Enclosed please find the comments of Catskill Mountainkeeper, Delaware Riverkeeper Network, Earthjustice, the Natural Resources Defense Council and Riverkeeper on the Revised Draft Supplemental Generic Environmental Impact Statement on the Oil, Gas and Solution Mining Regulatory Program, Well Permit Issuance for Horizontal Drilling and High-Volume Hydraulic Fracturing to Develop the Marcellus Shale and Other Low-Permeability Reservoirs, issued September 7, 2011, and draft regulations (Proposed Express Terms 6 NYCRR Parts 52, 190, 550-556, 560, 750.1, and 750.3), issued September 28, 2011.

Memorandum

RE: Technical Comments Summary Report: Expert Team Review of the 2011 Revised Draft SGEIS on the Oil, Gas and Solution Mining Regulatory Program and Proposed High-Volume Hydraulic Fracturing Regulations

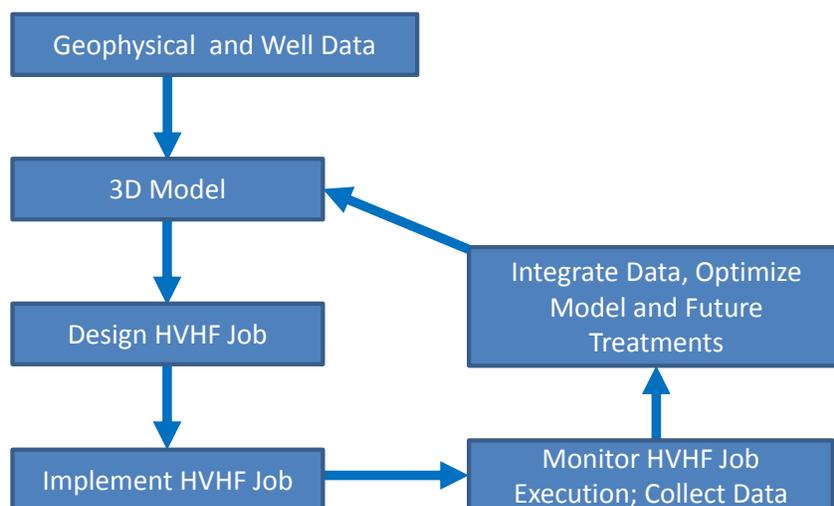
NYSDEC's consultants (Alpha Geoscience and ICF), the Ground Water Protection Council, HCLLC, and industry all agree:

- There is a need for computer modeling on new gas shale play areas to simulate various fracturing designs and their effects on the height, length, and orientation of the induced fractures;
- After the HVHF treatment is actually performed, gathered data should be used to optimize future treatments; and
- There is technology available to further refine treatment design, including microseismic fracture mapping, tilt measurements, tracers, and proppant tagging.

However, these points of agreement are not reflected in the RDSGEIS, permit conditions, or NYCRR revisions. Remarkably, the 2011 RDSGEIS only has a few paragraphs in the entire 1,537 page document that discuss the importance of HVHF modeling and post-fracture assessment work (Chapter 5.8), and these recommendations are later disregarded in Chapter 7 proposed mitigation.

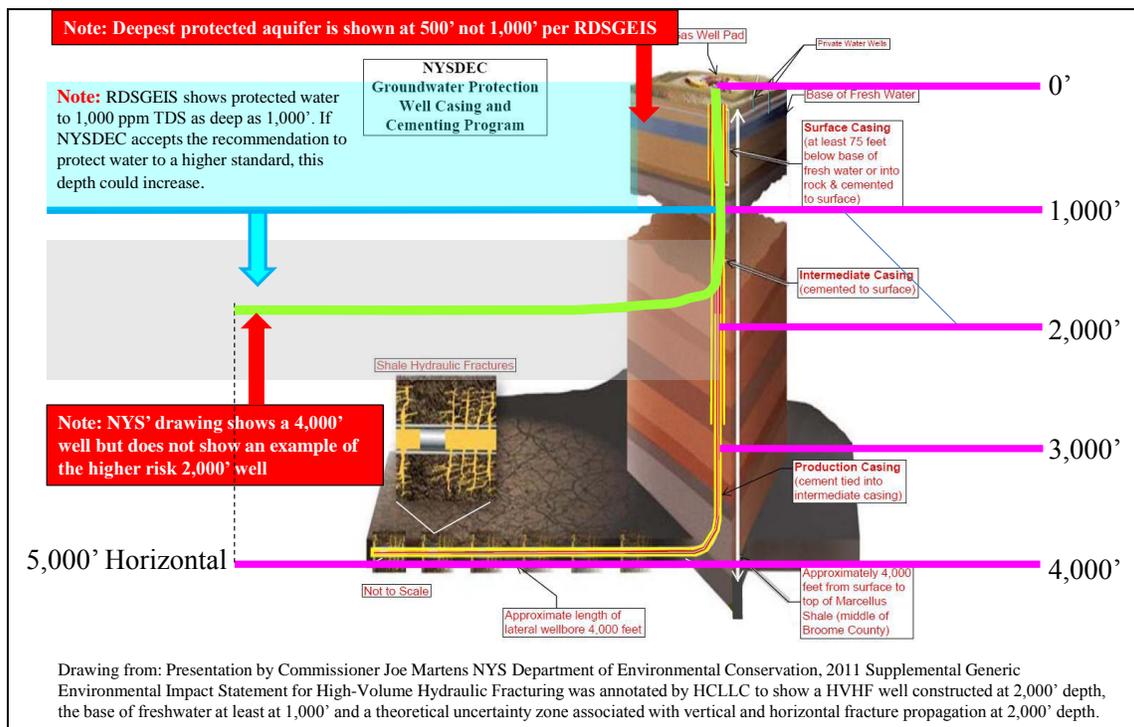
The drawing does not represent the highest risk wells proposed in the 2011 RDSGEIS. The highest risk wells allowed under the 2011 RDSGEIS would be drilled into a thin section of the Marcellus Shale at a 2,000' depth, with protected water located above at 1,000'. Below is an annotated version of this wellbore schematic, prepared by HCLLC, showing the higher risk wells proposed under the RDSGEIS.

As explained in Chapter 9 of this report, if a HVHF treatment intersects with a nearby improperly abandoned well, the potential exists for the improperly abandoned well to become a vertical conduit, and therefore transfer hydraulic fluid and mobilized gas to protected aquifers. Additionally, the pollution risk posed by possible HVHF intersections is not limited to improperly abandoned wells; existing wells that were poorly designed and constructed could also pose a risk.

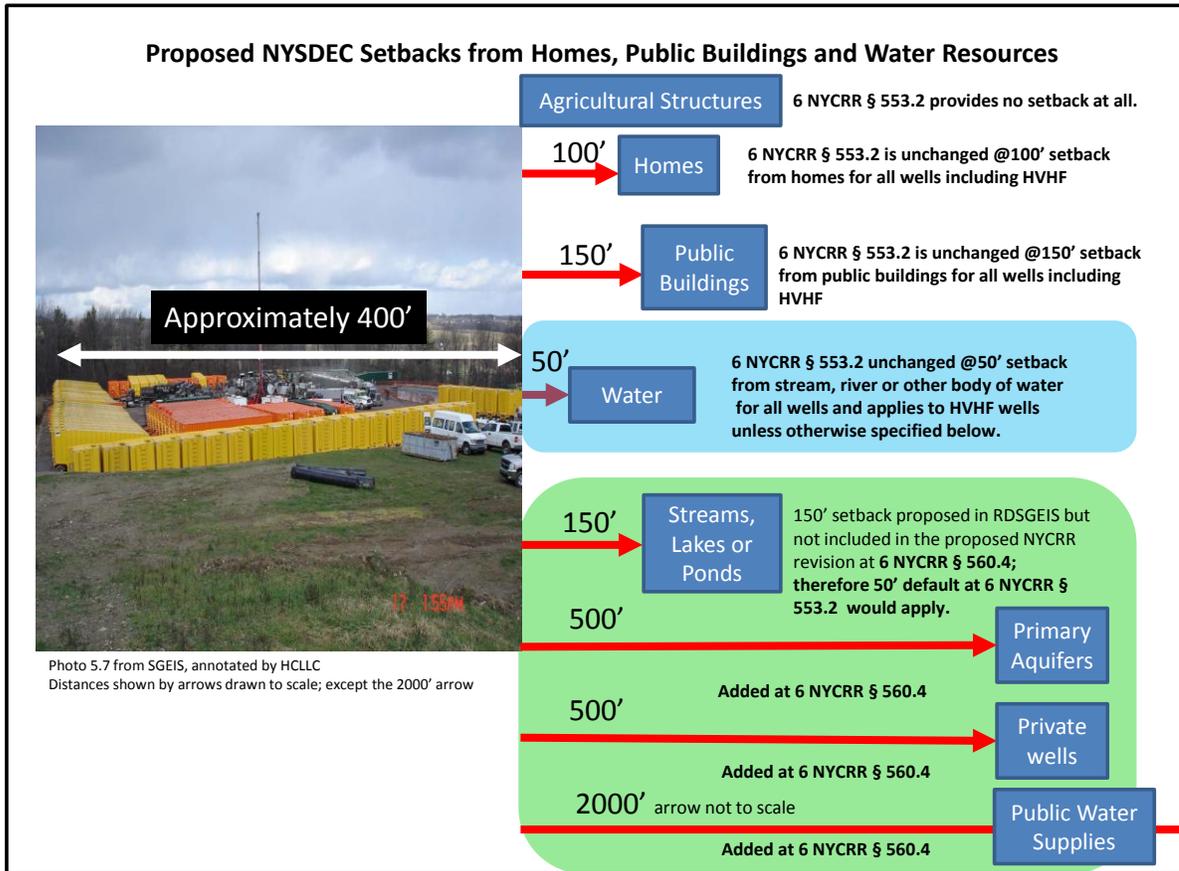
As shown in the figure below, the setbacks currently proposed in the RDSGEIS and in the NYCRR are inadequate. Shale drilling and HVHF operations within 100'-150' of homes and public buildings pose a direct safety risk, not to mention the health and quality of life impacts presented. NYSDEC is proposing

Recommendation No. 68: Improved setbacks should be included in the SGEIS as a mitigation measure and codified in the NYCRR. Specifically, the SGEIS and NYCRR should be revised at 6 NYCRR § 553.2 to include the following minimum setbacks: homes, public buildings, and schools (1,320'; ¼ mile); private and public wells, primary aquifers, and other sensitive water resources (4,000'); and other water resources (660'; 1/8 mile). Additionally, NYSDEC should clarify the authority of local zoning authorities to establish minimum setbacks that are more protective than NYS' minimum standards in order for localities to address unique and site-specific local concerns and community characteristics.

Figure 1: Figure 2 from Fisher (2010) showing the well centerline and a depth to the top of the fracture zone.

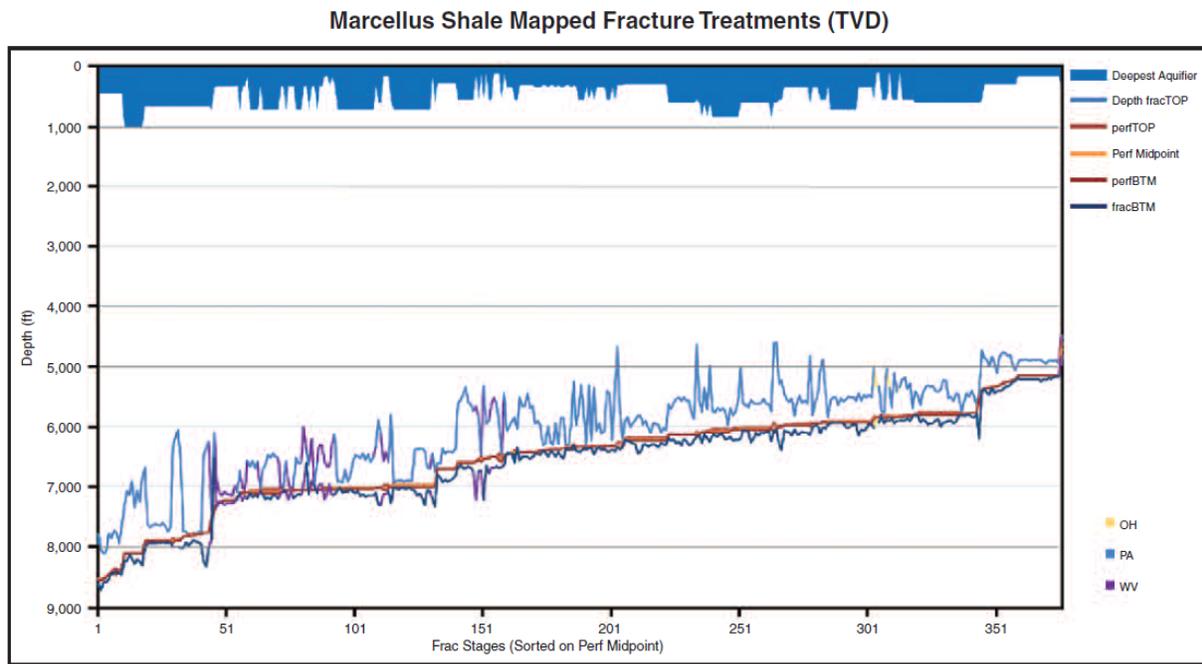
Industry designs fracking jobs to keep the fractures in the shale, but data show that the results of the fracking do not always or even often verify the design. The industry rarely monitors or measures the actual extent of fractures (RDSGEIS, p. 5-88), beyond monitoring pressure and injected fluid during fracking. The RDSGEIS references Fisher (2010) as being proof that fractures do not extend into the aquifer zone, but his data actually show that fractures commonly go out of formation (Figure 1). His data show many instances of the top of the fracture zone being more than 1000 feet above the centerline of the shale. As the depth to the centerline of the shale decreases from 8000 to 5000 feet, the vertical fracture growth also appears to decrease from 2000 feet above to 500 feet above the centerline of the shale. The apparent trend to fracture growth above the formation decreasing with decreasing depth may relate to the pressure on the rock or its hardness. The data were not sorted according to formation type and there is no data concerning shale thickness, therefore it is unknown whether fractures extend further in some types of rock or whether out-of-formation fractures are more common with thinner shales.

- *The RDSGEIS and regulations should require geophysical logging and microseismic tests to map how far fractures extend out of formation, and the density of the fractures in different formation. This information should be publically available so that all companies can benefit from experience and so that the public can better understand the process.*
